NUMBER: S.I. M20-58

SUBJECT: PRESSURIZATION OF BENDIX AND SLICK MAGNETOS ON
TELEDYNE CONTINENTAL MOTORS TSIO360GB ENGINES
AS INSTALLED ON THE MOONEY M20K PER TELEDYNE
CONTINENTAL MOTORS SERVICE BULLETIN M81-26

service bulletin

M81-26

FIG. 1

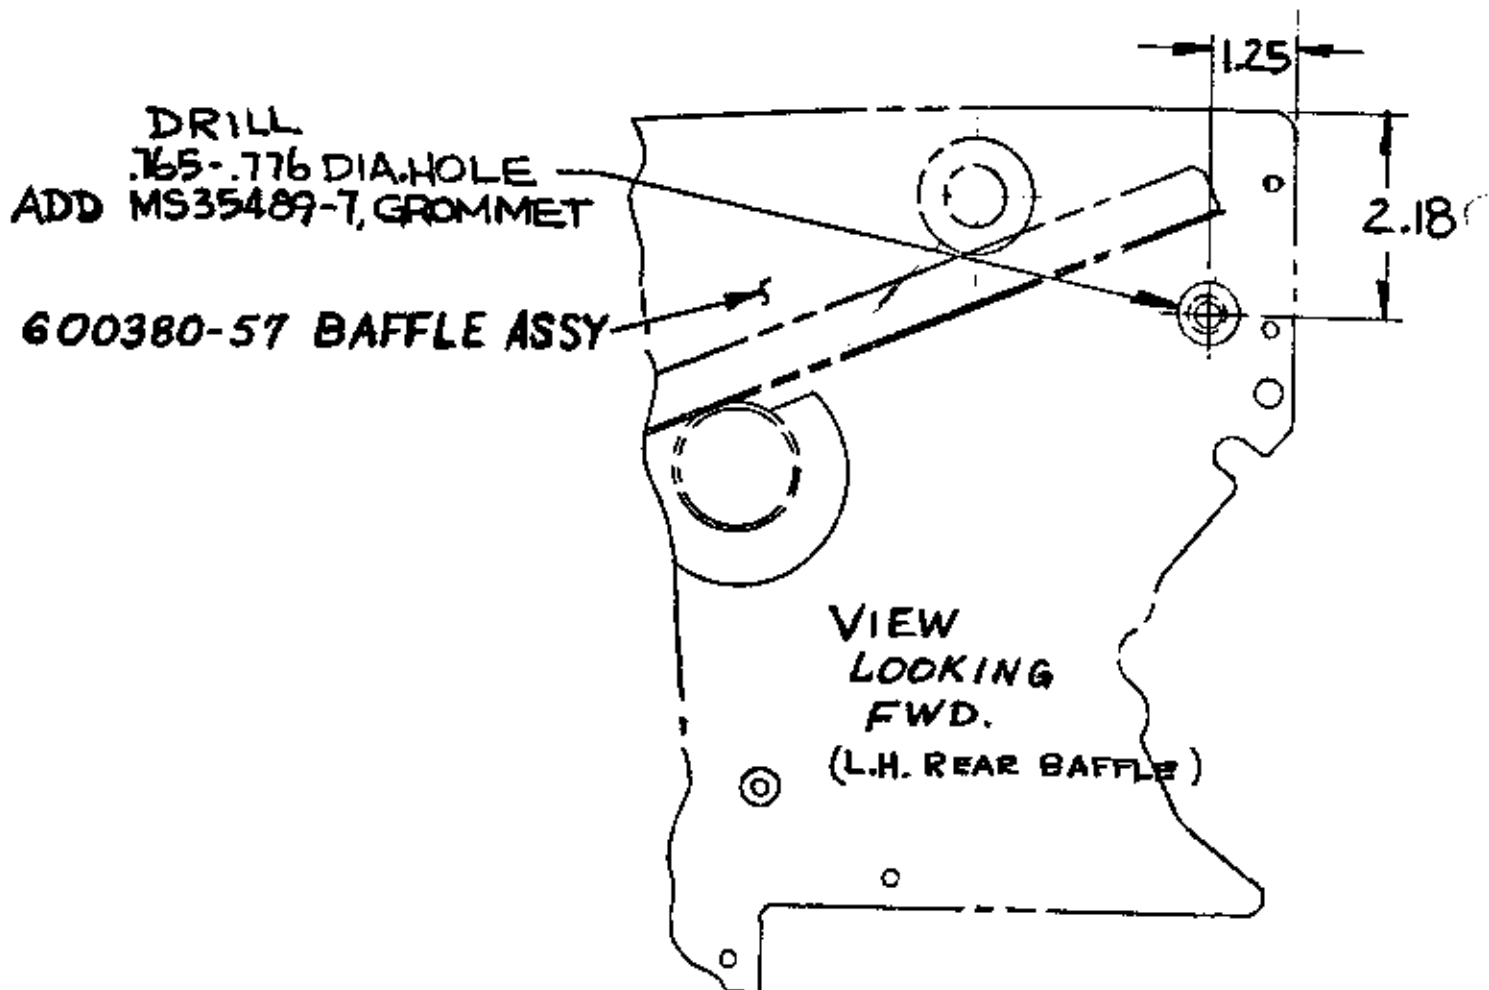
Drill hole in 600380-57 baffle assy per the dimensions
shown in Figure 1 and install MS35489-7 grommet in the
hole. Route the tube or hose for either the Bendix
or Slick retrofit modification through this hole and
proceed with the instructions given in the applicable
kit to complete the modification.

FIGURE 1

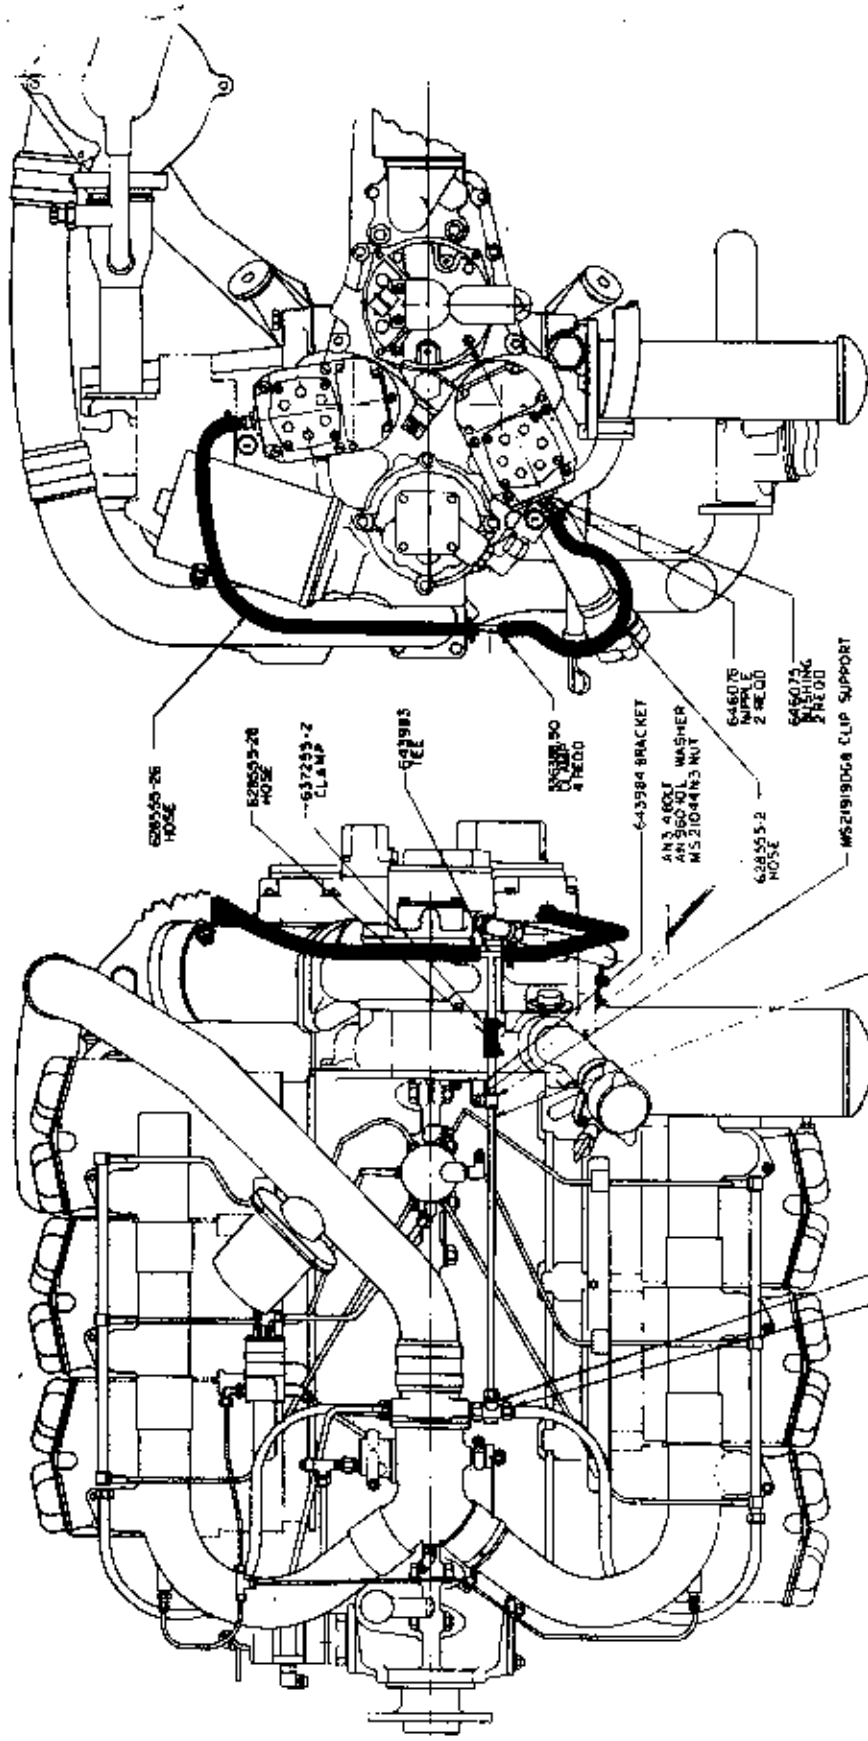
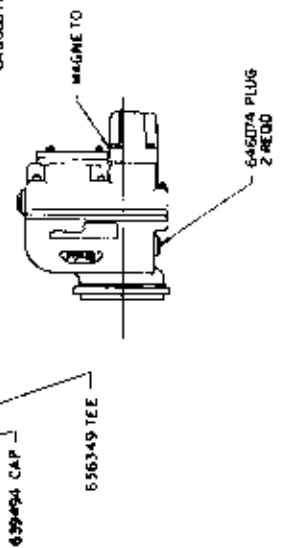
For improved altitude performance, we recommend that owners of TSIO-360GB engines equipped with Bendix S6RN-20 magnetos install the pressurization kit EQ6565 in accordance with Figure 1.

NOTE: ① PLUG BREAKER VENT HOLES FROM INSIDE OF COVER WITH RTV, TWO HOLES PER MAG

FIGURE 2

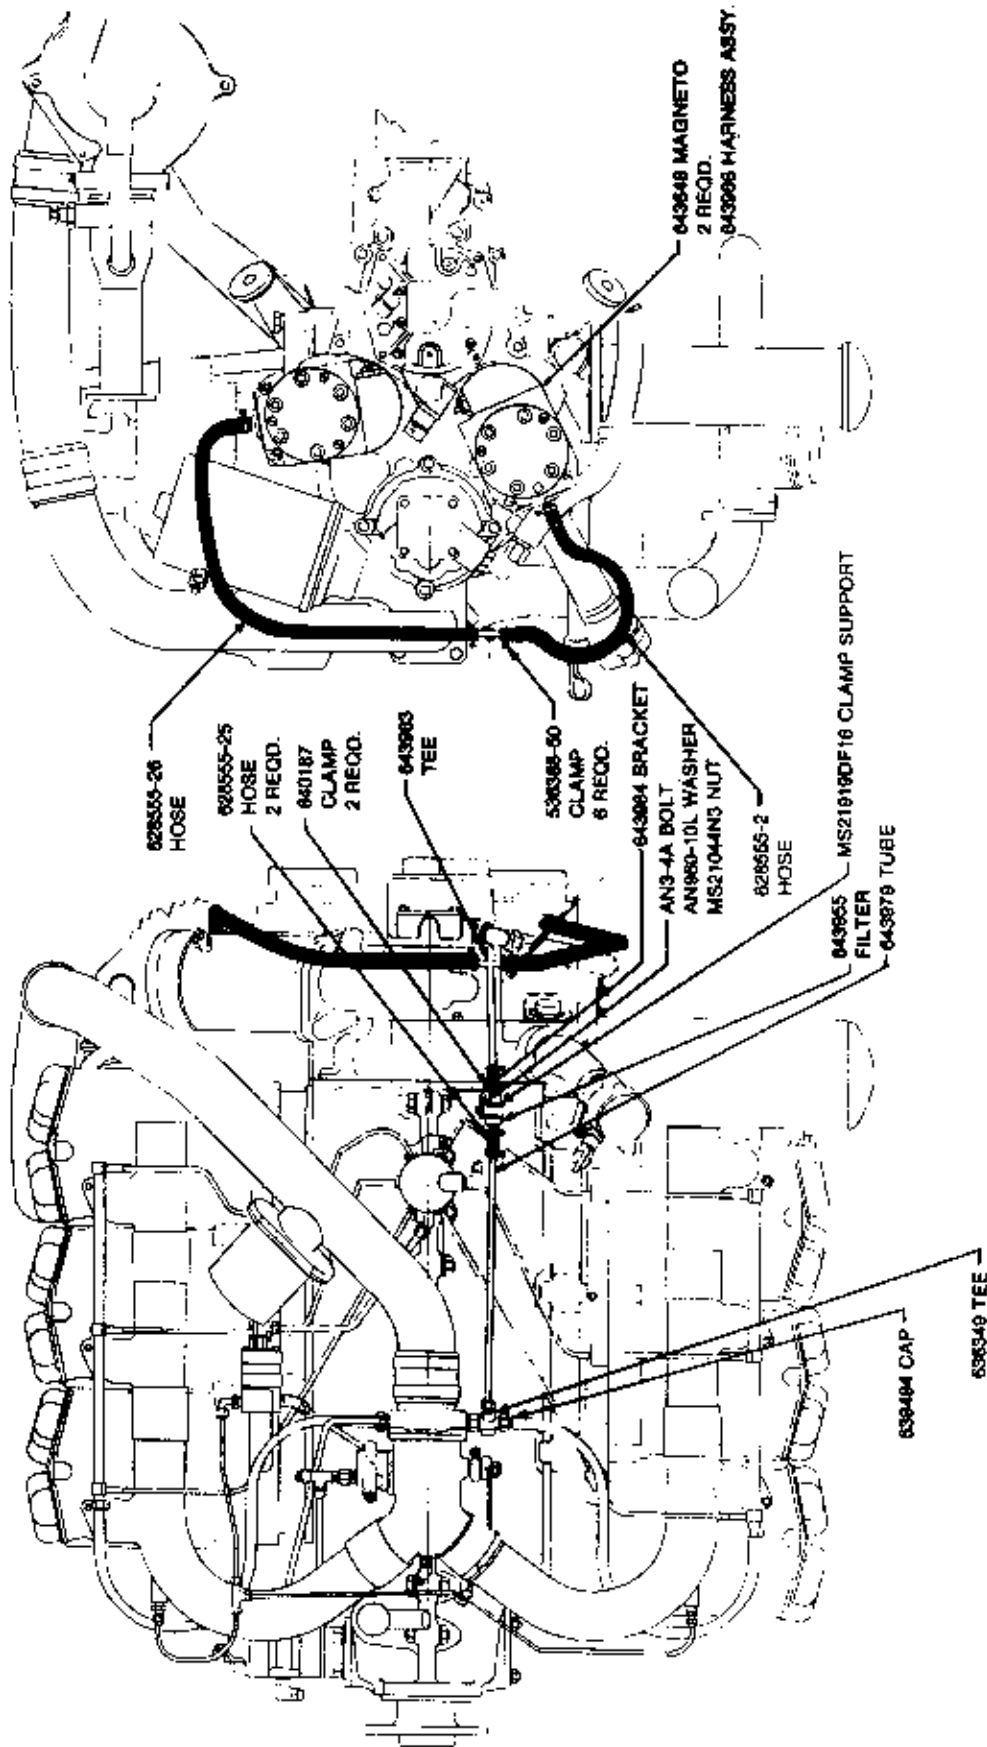
Installations with Slick Magnetos can be pressurized using kit EQ 6569 in accordance with Figure 2. Reset timing in accordance with instructions in Overhaul Manual form X30030A.
